SUBDIVISION REVIEW SHEET**CASE NO.:** C8-2018-0165.3A**Z.A.P. DATE:** July 20, 2021**SUBDIVISION NAME:** Cascades at Onion Creek East, Phase Three**AREA:** 23.1107 acres**LOTS:** 120**APPLICANT:** M/I Homes of Austin, LLC
(William G. Peckman)**AGENT:** LJA Engineering Inc.
(Russell Kotara, P.E.)**ADDRESS OF SUBDIVISION:** 2333 Cascades Ave**WATERSHED:** Onion Creek**COUNTY:** Travis**EXISTING ZONING:** I-SF-2**JURISDICTION:** Full Purpose**PROPOSED LAND USE:** Residential / Open Space / Right-of-Way**DEPARTMENT COMMENTS:**

CITY OF AUSTIN –DEVELOPMENT SERVICES DEPARTMENT
SUBDIVISION APPLICATION – MASTER COMMENT REPORT

CASE NUMBER: C8-2018-0165.3A
REVISION #: 00 UPDATE: U0
CASE MANAGER: Cesar Zavala PHONE #: 512-974-3404

PROJECT NAME: Cascades at Onion Creek East Phase Three Final Plat
LOCATION: 11601 S IH 35 SVRD NB

Exhibit B: Proposed plat

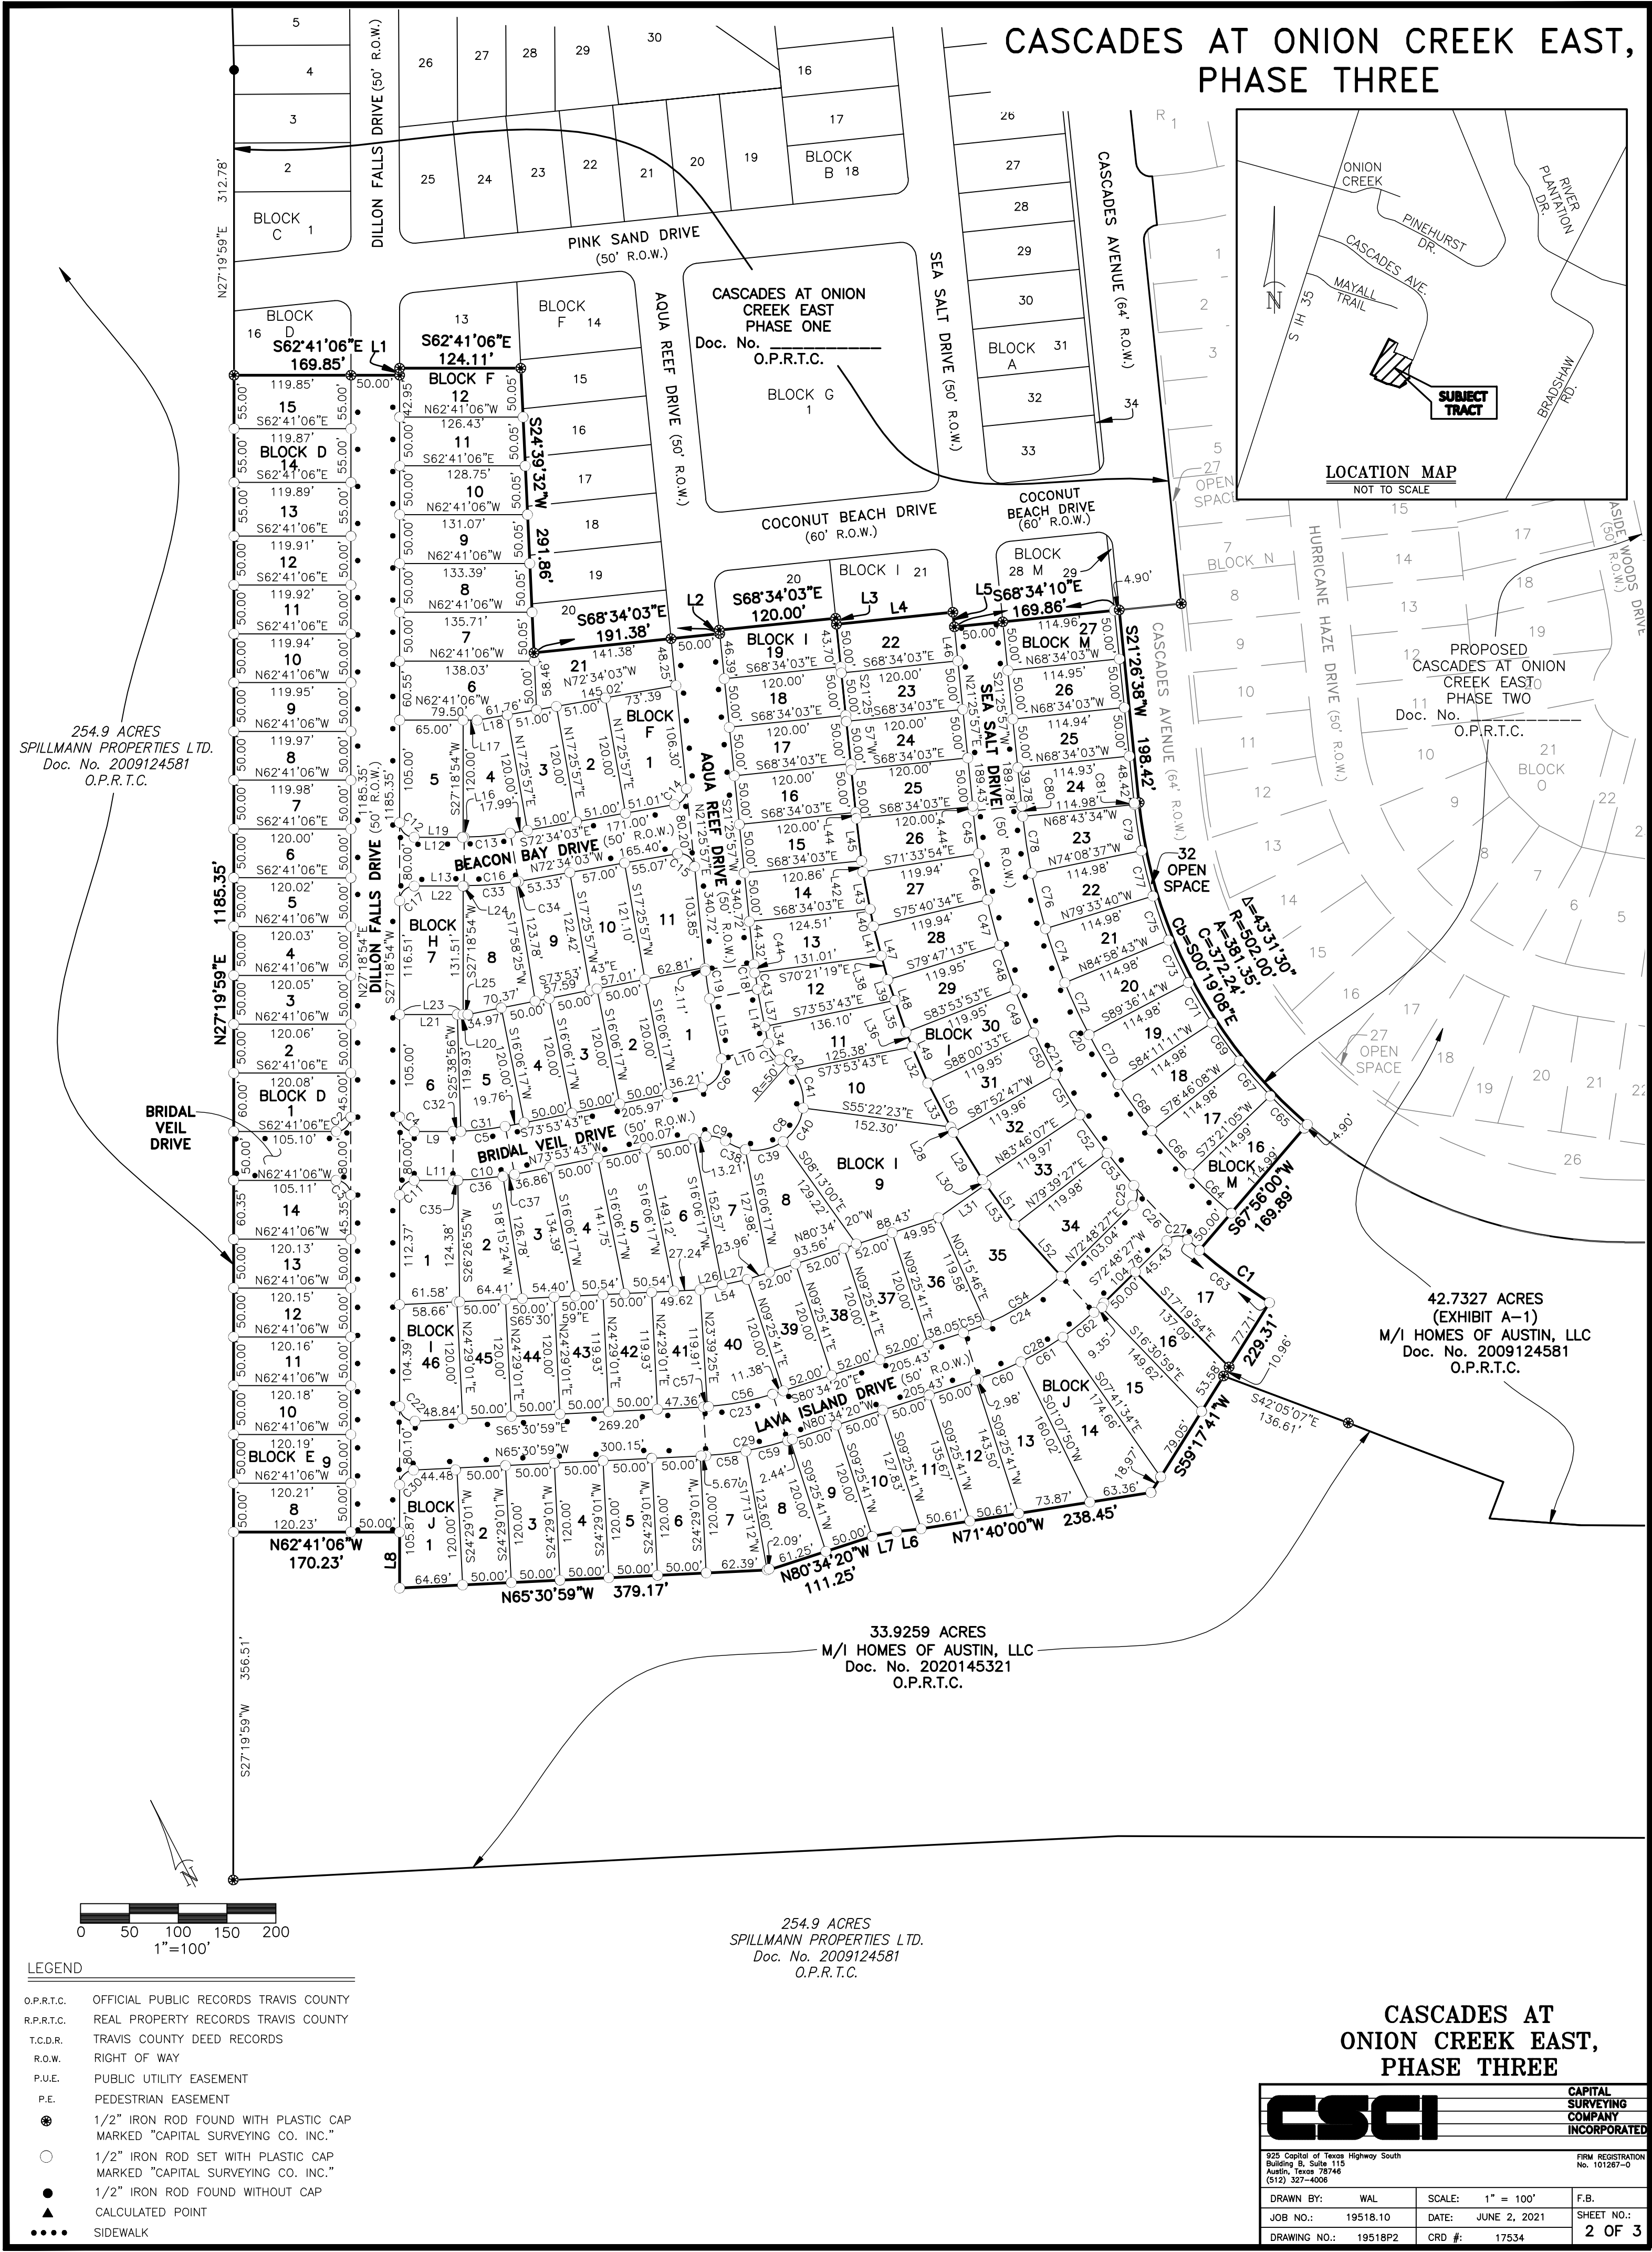
EL 2. Please label lot 32 Open Space as a PUE and add an additional 10' electric distribution, electric telecom, and electric fiber easement from the open space lot.

SR 1. Add the following plat note to list any lot that will be maintained by the property owner or organization, such as opens space lots. 25-1-83 or 30-1-113
"Lot XX, Block YY will be maintained by the owner or his/her assigns. No residential development shall be allowed on this lot. If conveyed to a public entity or neighborhood organization, recreation facilities and rest areas may be constructed".

SR 2. Amend the Land Use Commission approval block to read as follows: 25-1-83 or 30-1-113:
Accepted and authorized for record by the Land Use Commission of the City of Austin, Texas, on this, the _____ day of _____ 20__.

SR 3. Update the application submittal date on the plat to June 21, 2021. (L.D.C 25-1-83)

SR 4. Verify that the lots with residential use meet SF-2 lot requirements to avoid amendments to the plat during the Residential Permitting phase. Lots for residential development should have a minimum lot size of 5,750 square feet and have a minimum lot width of 50 feet. Lots 7 and 8 Block J do not appear to have a 50 foot width, and Lots 25, 26 and 27 Block M do not have minimum lot size of 5,750 feet as shown in the lot table. (L.D.C. 25-2-492)

SR 5. On Sheet 3 in the table for Block M, add the lot number for the last listed lot with a 2,850 square footage.
